Department of
Conservation and
Development

Contra Costa County

**Re: Comments on the Department of Water Resources' 2015 California WaterFix Section
404/10 Application
Public Notice SPK-2008-00861**

Attachment B**Contra Costa County Comments on WaterFix RDEIR/SDEIS****General Comment on the Inadequacy of All BDCP Alternatives**

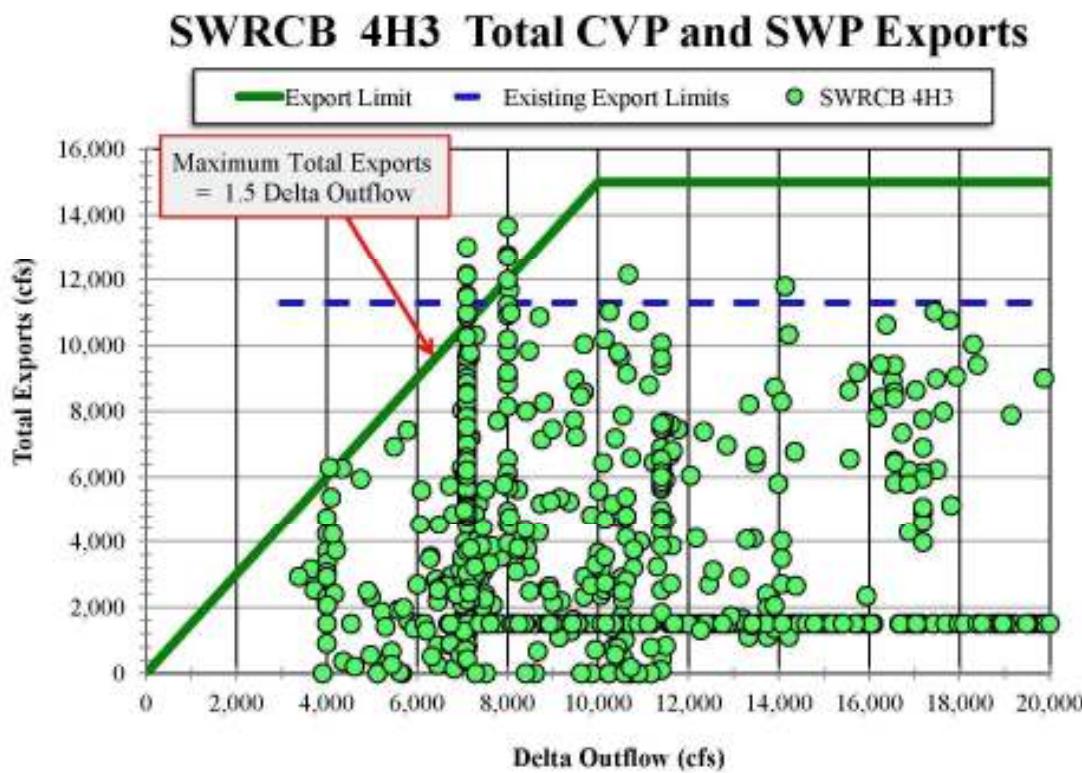
According to Appendix C of the RDEIR/SDEIS, the SWRCB requested that an additional alternative be analyzed (4H3) which would be operated to much higher Delta outflow

requirements specified by the SWRCB. Unfortunately, DWR and Reclamation did not modify the WaterFix infrastructure to adapt to these higher outflow requirements so the environmental benefits and viability (with respect to cost and water supply benefits) of a higher Delta flow alternative were not tested and disclosed. It is interesting, however, that the corresponding total exports versus Delta outflow graph for SWRCB Alternative 4H3 shown in Figure C-3 does represent less water being exported in drier periods. The reduced exports in this SWRCB alternative are consistent with the suggested low outflow export limit (total exports = 1.5 x Delta outflow).

A new Draft EIR/EIS should be prepared that includes more holistic alternatives that reduce exports during drier months (e.g., in a fashion similar to the suggested exports = 1.5 inflow limit) and are able to capture “new” water during periods of high Delta outflow. That would contribute to achieving the coequal goals as well as improving water quality in the Delta. The dismal WaterFix proposal hinders any progress to achieving these goals. The new Draft EIR/EIS should then be released for public review and comment.

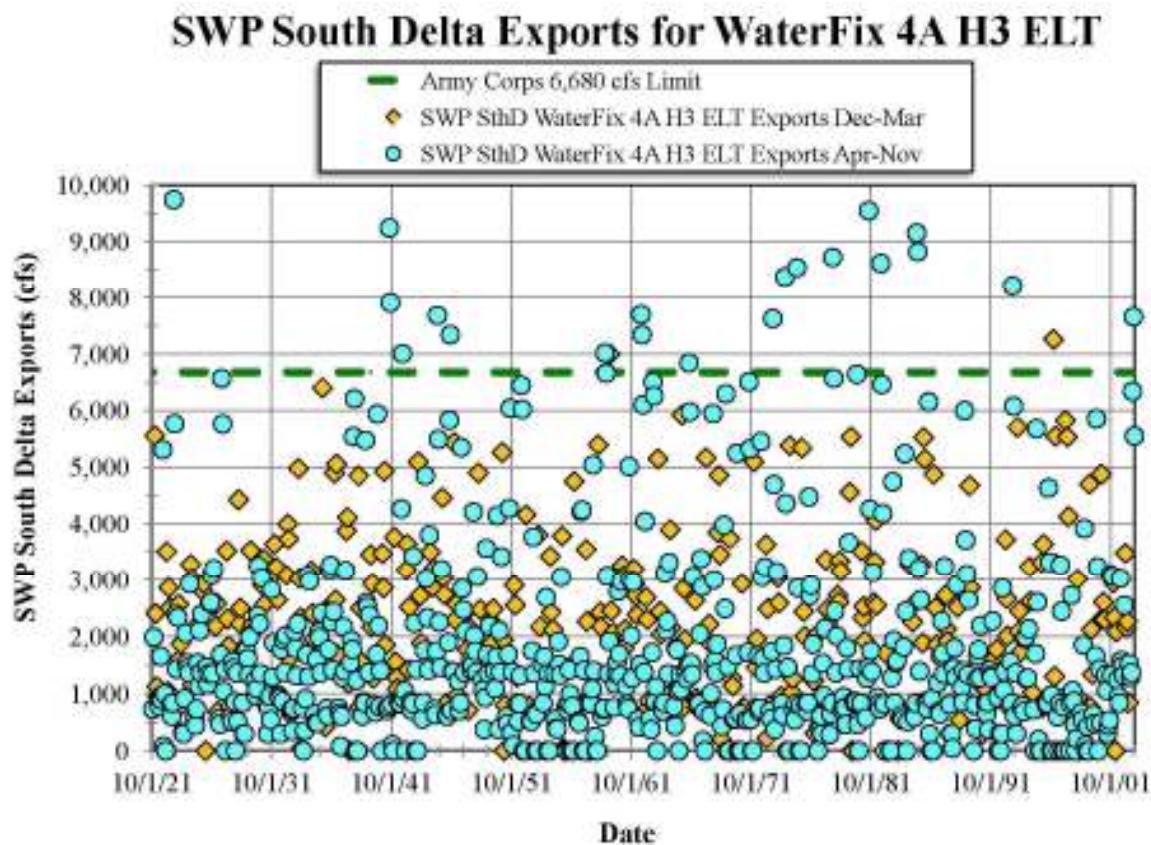
Figure C-5 shows the WaterFix analysis SWP South Delta export data for Alternative 4A, Scenario H3, at early long term, for April through November when the Army Corps limits of 6,680 cfs apply. The simulated inflows to Clifton Court (SWP through-Delta exports) are as high as 9,750 cfs with total south Delta export as high as 14,350 cfs. This is well in excess of the permitted values for this period, and is inconsistent with the WaterFix project claim of ecosystem benefits because exports from the south Delta will be reduced.

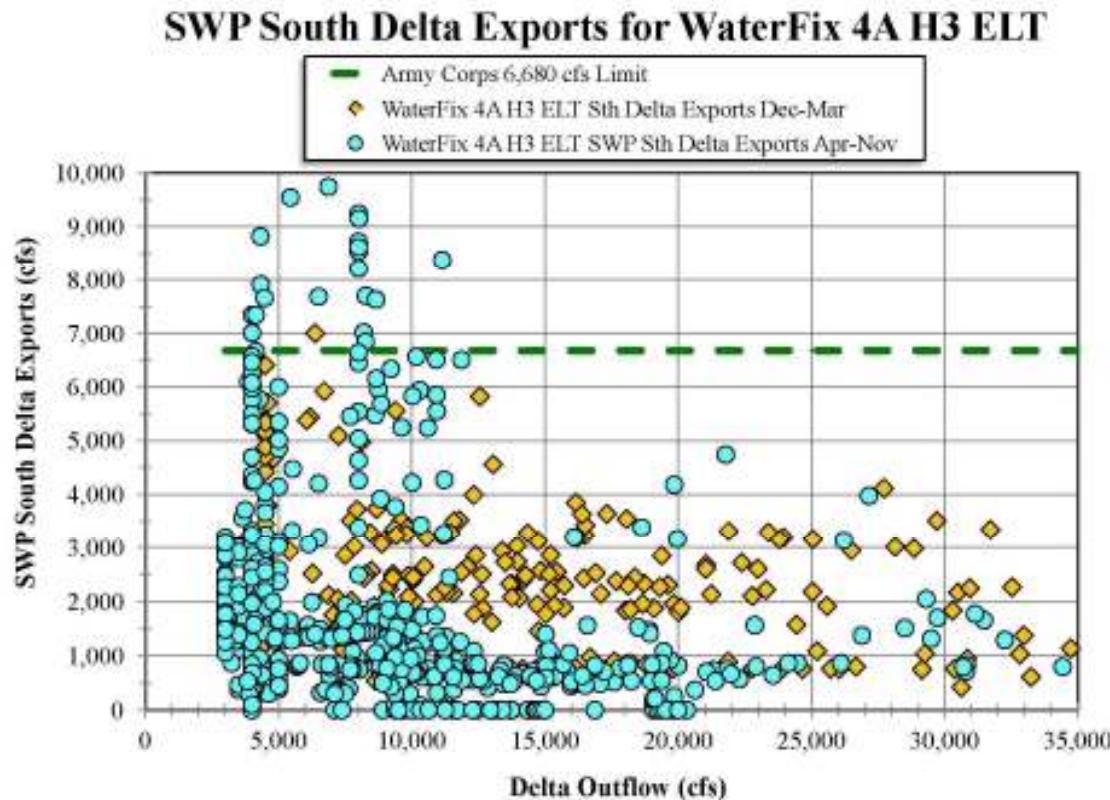
Figure C-6 shows the same SWP south Delta export data as Figure C-5, but this time plotted as a function of Delta outflow. The violations of the Army Corps limits occur during drier months when Delta outflows are lower. This is again directly contrary to the principle of taking a "Little Sip" during drier periods, *i.e.*, reducing exports relative to existing levels.

A new Draft EIR/EIS must be prepared that includes new alternatives that comply with the U.S. Army Corps of Engineers limits on inflow to Clifton Court Forebay, and other legal requirements set by the SWRCB and the biological opinion, and released for public review and comment.

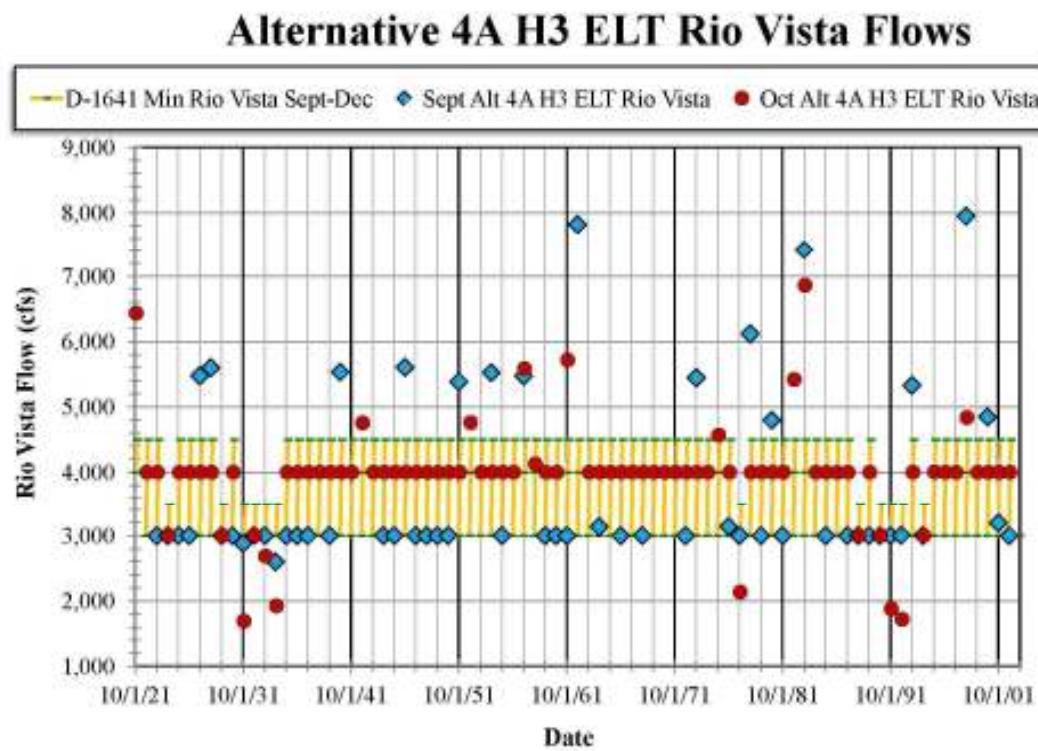
SWRCB Water Rights Decision 1641 requires minimum Rio Vista flows be met in the fall (September through December). As shown in Figure C-7, the monthly Rio Vista flows for September and October for the WaterFix preferred alternative (Alternative 4A, Scenario H3 at Early Long Term) fall well below the D-1641 requirements in a number of the drier years.

The WaterFix RDEIR/SDEIS is inadequate because it fails to comply with the SWRCB minimum flow requirements at Rio Vista and fails to clearly disclose these significant violations to decision makers and the public. A new Draft EIR/EIS must be prepared which includes new alternatives that comply with all legal requirements including the Rio Vista minimum flow standards and then be released for public review and comment.

Figure C-8: Monthly Old and Middle River flows for the WaterFix preferred alternative (Alternative 4A, Scenario H3 at Early Long Term) compared to the OMR flows for the existing basecase. Reverse flows still remain most of the time even with the proposed north Delta intakes.

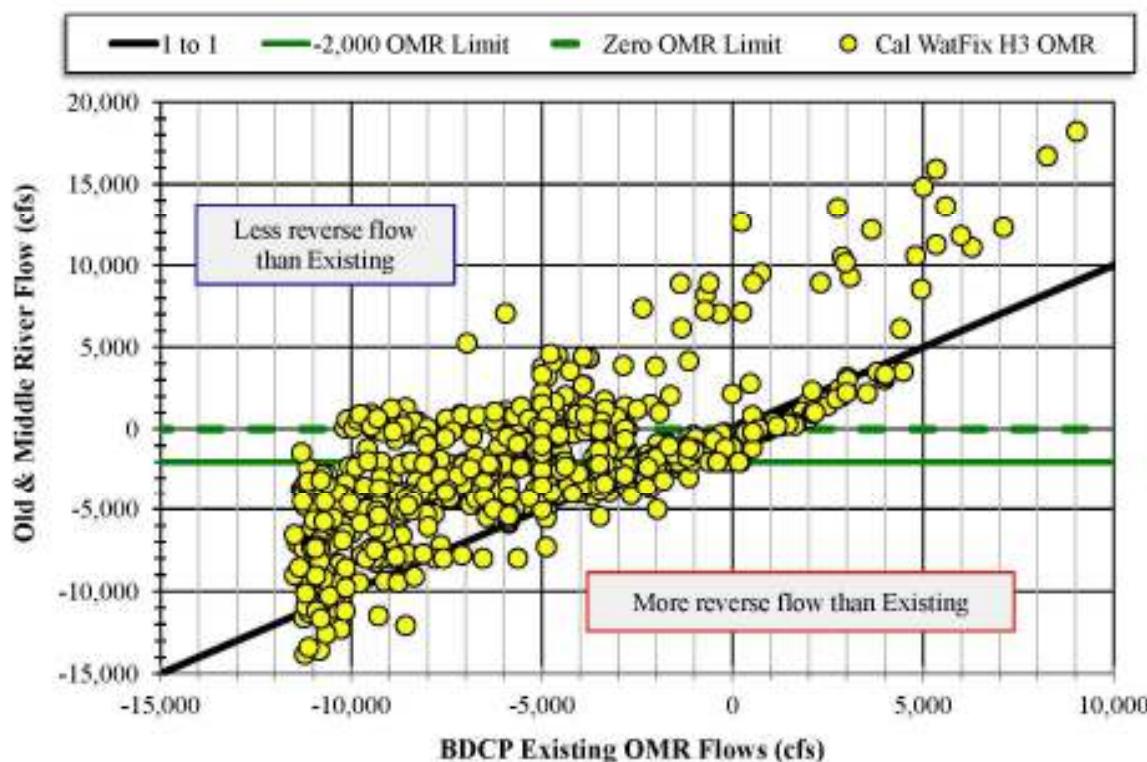
Figure C-8 shows simulated monthly Old and Middle River flows for the WaterFix preferred alternative (Alternative 4A, Scenario H3 at Early Long Term) compared to the OMR flows for the existing basemode, as a scatter plot. Many of the monthly reverse flows are very large in the base case (x-axis) and would remain large even with implementation of the WaterFix preferred alternative with its new north Delta intakes. Some of the existing large reverse flows would get even worse with WaterFix. OMR values of -12,000 cfs in the basemode would worsen to -14,000 cfs and harm resident fish in the Delta. The published claims that the RDEIR/SDEIS and the proposed project will minimize reverse flows are untrue, and could be viewed as disingenuous.

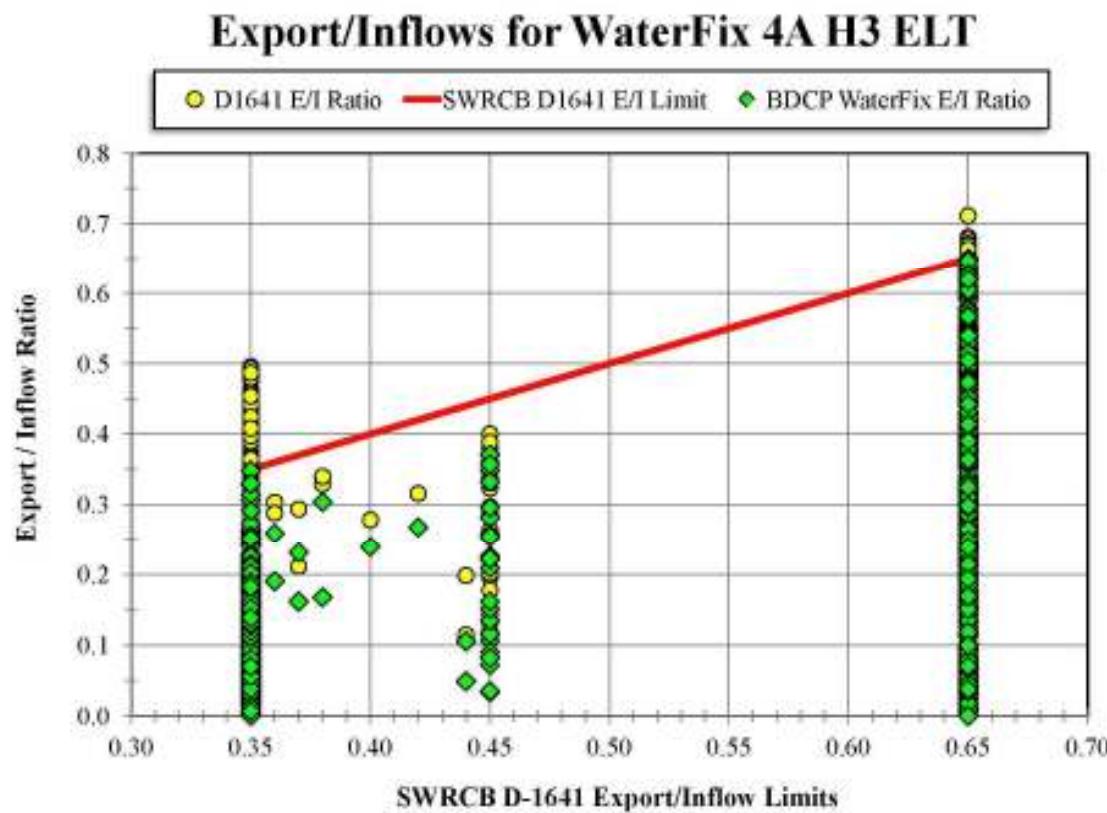
Figure C-9 shows the RDEIR/SDEIS simulations of monthly export/inflow ratios for the WaterFix preferred alternative (Alternative 4A, Scenario H3 at Early Long Term). The export ratios are computed according to the correct SWRCB Water Rights Decision 1641 definition (yellow circles), as well as the faulty definition used in the RDEIR/SDEIS (green diamonds). During periods when the export/inflow is required by D-1641 to be 0.35 or less, the WaterFix project would export almost 50% more water than permitted (E/I as much as 0.5). During periods when an export/inflow ratio of 0.65 is required under D-1641, the WaterFix preferred alternative E/I ratio is as high as 0.71.

A new Draft EIR/EIS must be prepared that analyze alternatives that comply with the SWRCB's export/inflow standards as well as the existing Army Corps limits on inflow to Clifton Court and the San Joaquin inflow to export ratios in the biological opinions. Additional full model runs could still be included to disclose individual impacts to the Delta ecosystem and water quality if

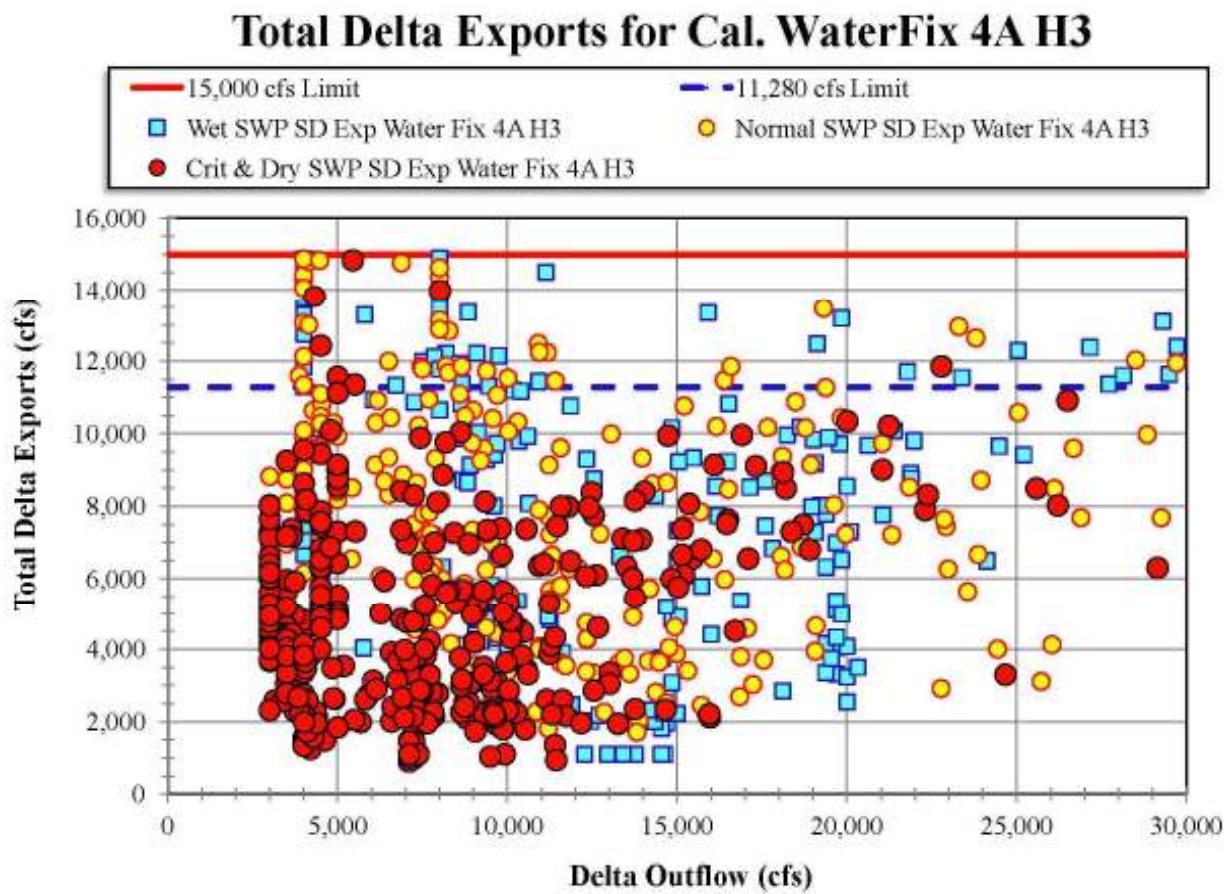
months when Delta outflows are very low (Figure 1, below), i.e., by taking advantage of the increase in maximum export capacity from 11,280 cfs under typical flow conditions and the existing Delta infrastructure, to 15,000 cfs with the proposed 9,000 cfs twin tunnels. This is contrary to the 2009 Delta Reform Act (Water Code section 85021) and threatens already stressed fish species.

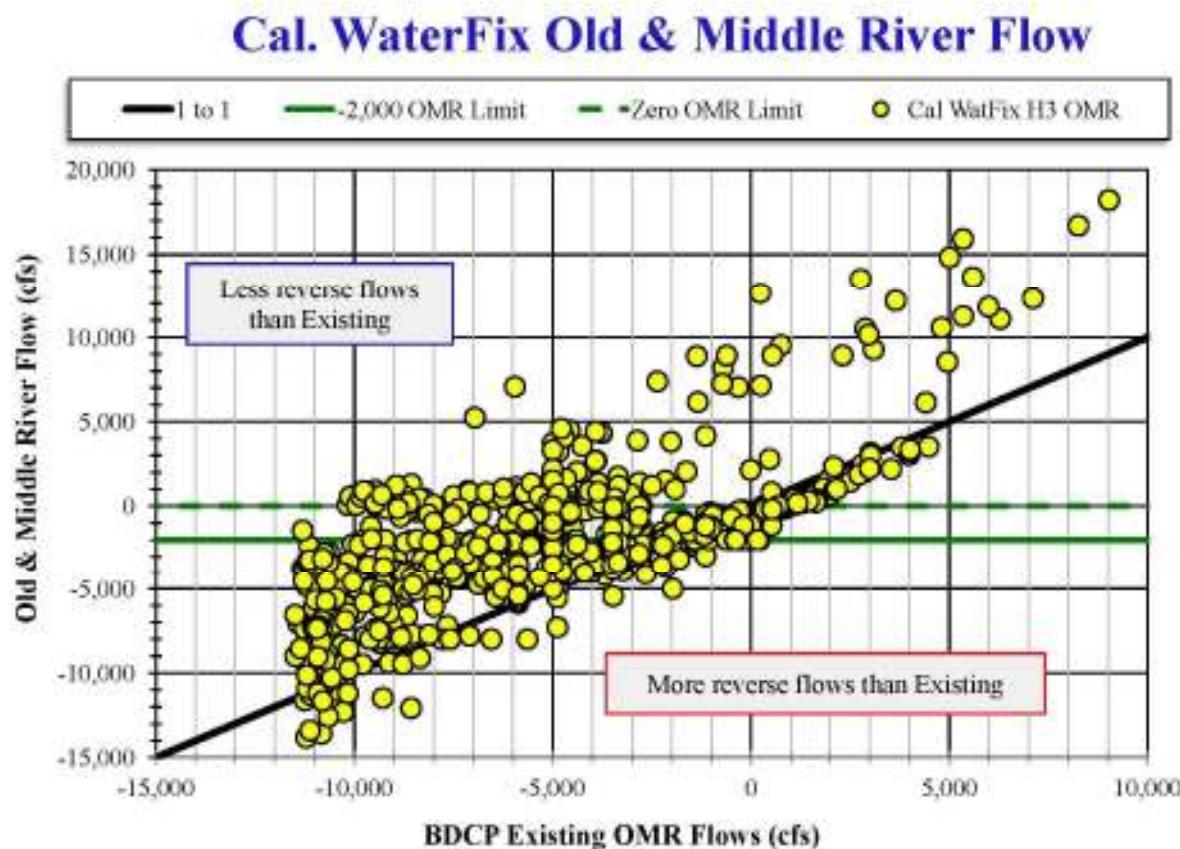
the WaterFix preferred alternative and continued use of the south Delta export intakes for half of the SWP and CVP alternatives does not minimize reverse flows in the south Delta (see Figure 2 below). Fish are resident in the Delta year round. Salvage of other species such as Striped bass, largemouth bass, white cat fish and Mississippi silversides are already large under existing conditions (see Grimaldo et al., "Factors affecting fish entrainment"). This is also likely to be a problem for sturgeon¹. The WaterFix project sets OMR limits for some of the year and will redirect impacts to July, August, September and October. Fish that are resident in the Delta year round may not be declining now, but they will if that period is subjected to increased reverse flows because of the WaterFix project.

Figure 3-2. Old and Middle River flow when HORB is closed

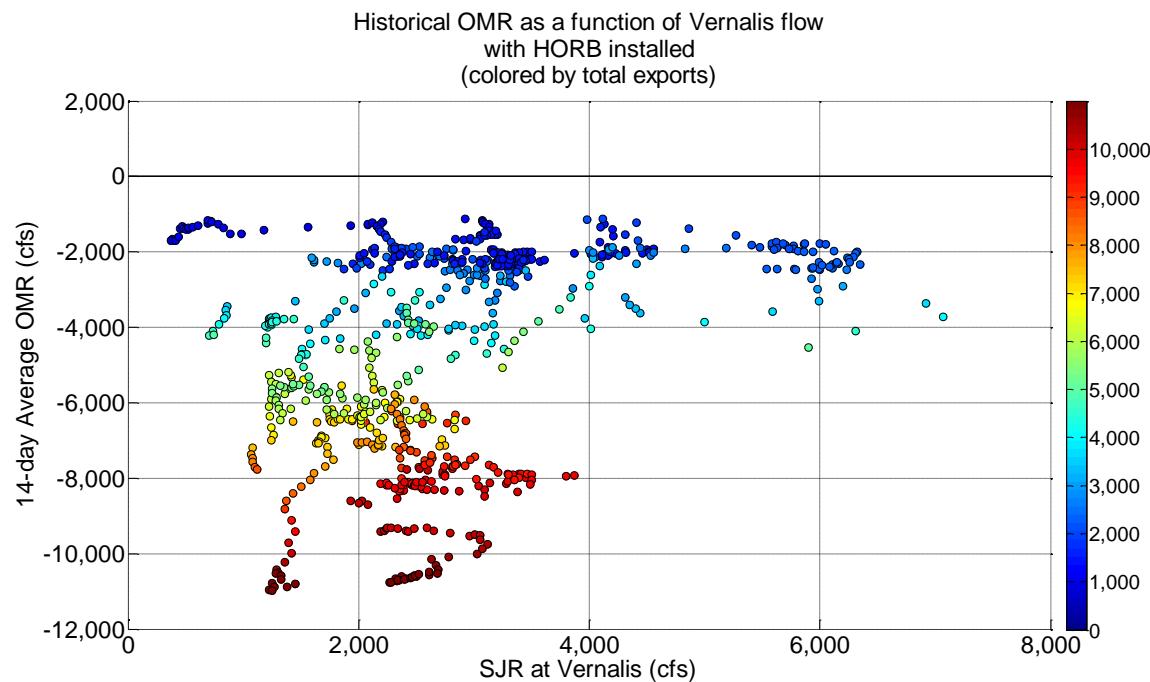
This inconsistency is demonstrated by reviewing measurements of OMR flows at times when a barrier has been installed at the head of Old River in the past. Historically, a temporary barrier of rocks at the head of Old River has been constructed in the fall or spring¹. Review of OMR flows that were measured when the HORB was installed confirms that OMR is never positive with the HORB installed (Figure 3-2).

Pumping at the existing CVP and SWP export facilities in the south Delta (Jones and Banks, respectively) contributes to negative OMR – the greater the total pumping at the existing south Delta facilities, the more negative OMR (Figure 3-2). Limiting pumping at the south Delta facilities limits the negative OMR but cannot create positive OMR. Positive OMR can only occur with inflow from the San Joaquin River when the HORB is *not* installed.

Figure 3-3
Percent of Years with Excess Delta Outflow
Source: BDCP Draft EIR/EIS

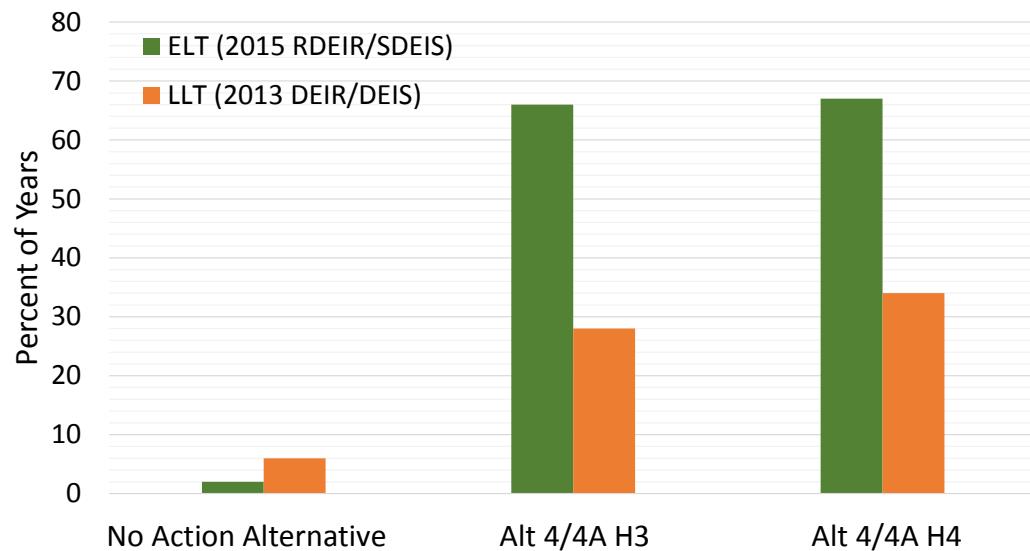
However, the BDCP modeling indicates that Delta outflow would exceed the amount necessary to meet minimum outflow requirements and salinity standards over 66% of the time in the early long term (ELT) for Alternatives 4/4A² H3 and H4 (Figure 3-3). In comparison, the No Action Alternative³ has excess Delta outflow in October only 2% of the time in the ELT.

The dramatic increase in the occurrence of excess flow under Alternatives 4/4A H3 and H4 in the ELT is not as substantial in the late long term (LLT) and is probably the cause for the different impact determinations between the ELT (as analyzed in the RDEIR/SDEIS) and the LLT (as analyzed in the 2013 BDCP Draft EIR/EIS). Although excess October Delta outflow occurs less often in the Alternative 4/4A LLT modeling than in the Alternative 4/4A ELT modeling, the frequency of occurrence in the LLT modeling is also unrealistic.
